Determination 2018/066

Regarding the authority's decision to issue a code compliance certificate for alterations to a relocated house at 6984F State Highway 1, Pakaraka, Moerewa

Figure 2: Approximate plan

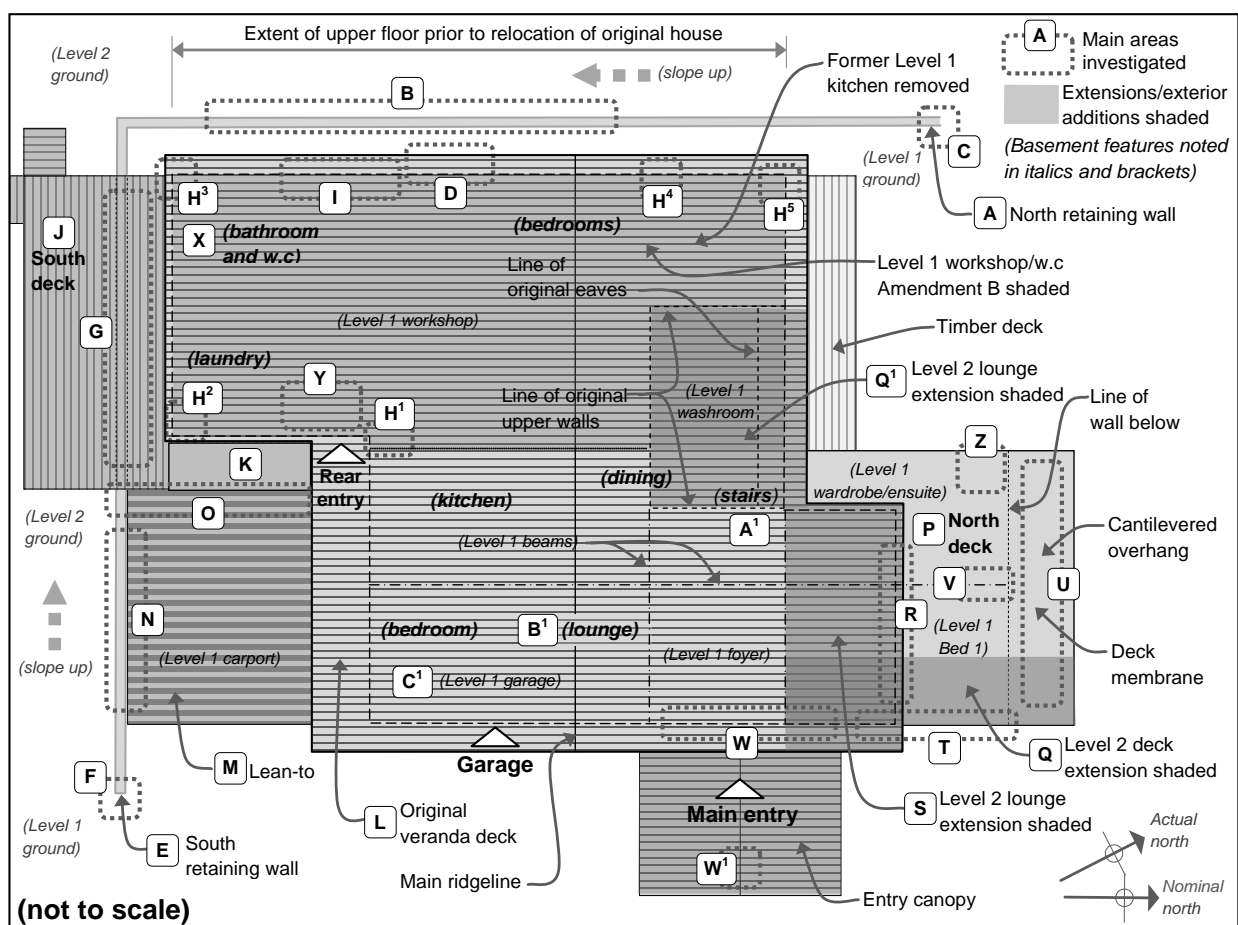
- Although final inspection photos show the wall and barrier 'true to line', pressure from backfill has distorted the wall by up to 300mm at about a third of its length from the south end (Area B).
- Water is seeping through the wall, with signs of water migrating to the lower 1m at the bottom of the wall. This is causing ponding on the path – to a depth of some 200mm at the south, suggesting no coil drain installed below the wall.
- Excavation to 500mm behind the wall found pug clay with some coarse gravel, with no sign of free-draining metal backfill (Area B).
- The applicants had removed the north (short) end of the wall, which had exposed the end of the 100mm diameter drain coil behind the wall (Area C).

- clearances to the floor level and cladding are well below those shown in the drawings, despite the applicants removing paving slabs to lower the ground
- the recycled workshop door has a severely decayed timber sill (Area D).

- The same clay and gravel fill was noted, but the drain coil is discharging water beyond the driveway despite the lack of drainage metal backfill (Area F).
- The south wall extends under and provides support to the south deck (Area G).

- The pile posts resulted from Amendments A and B, which changed the undeveloped subfloor in the consent drawings into a workshop area.
- The 125 x 125mm posts were cast into concrete pads and beams supported the original house during excavations of up to 2m of earth. A concrete nib was installed between the posts, and then the concrete slab floor was then poured within the nibs which encased the posts on three sides.
- The applicants had removed linings from some posts, with mould and black water marks visible on exposed timber and invasive moisture readings of 86% to saturation level were recorded (Areas H¹, H²).
- Invasive moisture readings were also taken through plasterboard into remaining columns, with moisture levels varying from 19% to 75% (Areas H³ to H⁵).

The condition of the pile post timbers suggested to me that the specified H5 timber treatment had not been achieved or that H5 posts [were] not installed.

- struts down from the bearer reduced to 50mm to align with the 50mm top plank of the retaining wall
- some 100 x 50mm blocks that are only nailed
- some struts not directly under the bearer, but are instead nailed alongside.
- Inspection photographs show an inspection of the deck framing/retaining wall during construction (although I note that the photos are undated, so it is not clear whether this was by the authority or the engineer – see paragraph 3.5.1).
- The deck ribbon plate appears to be fixed directly against the weatherboards.
- The deck boards have deteriorated and the ends are starting to decay.

- The deck area has increased, without clear documentation of the exact extent and no construction details for the new portion(s) (Area Q).
- The deck forms a roof to the master bedroom but has ‘little real slope’, with undersized drainage channels and outlets and evidence of ponding.
- There is a small upstand at the balustrade with no overlap at the deck edge and drainage provided via small drainage channels and internal outlets.

- At the junction with the lounge extension (Area S) floor clearance is only 30mm and weatherboards butt onto the deck floor – this would have been visible at the final inspection.
- Non-invasive moisture readings of 36% and 43% were recorded by the expert at the sides of the sill liner to the lounge doors, although a probe reading showed only minor elevation of moisture levels at 20% (showing that moisture in the reveals may relate to the aluminium joinery sections or to condensation).

- Apron flashings to the entry canopy allow water entry at the ends (Area W).
